# 2024 GPSRR Approach Consultation Report

November 2023

AEMO has prepared this document to report on the consultation completed on its approach paper for the 2024 General Power System Risk Review under clause 5.20A.2(c)(3) of the National Electricity Rules.

Figure 1 Flow duration curve on combined VNI interconnectors with VNI West augmentation

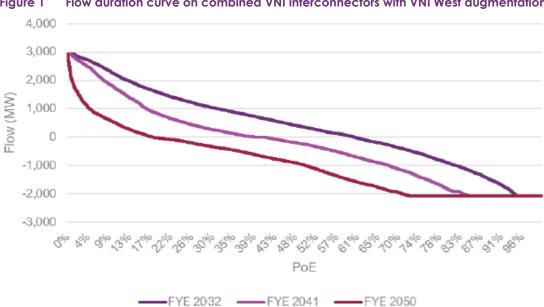
#### Simon Bartlett comment

#### **AEMO** response

Additionally, as per the VNI West PACR, the VNI West interconnector is designed and modelled to deliver a maximum transmission capability increase of 1,935 MW from Victoria to New South Wales and 1,669 MW from New South Wales to Victoria. As such, the double-circuit 500 kV lines that form VNI West and WRL will not be expected to carry all of the 4,240 MW of additional REZ limit capacity presented in the VNI West PACR instantaneously. As shown in Figure 1 below, taken from the VNI West PACR, the total maximum flow across all VNI (being the combined capacity of VNI West, the Buronga-Red Cliffs line, and the VNI East lines) will be limited to the range of 3 gigawatts (GW) flow from Victoria to New South Wales and 2 GW from New South Wales to Victoria.
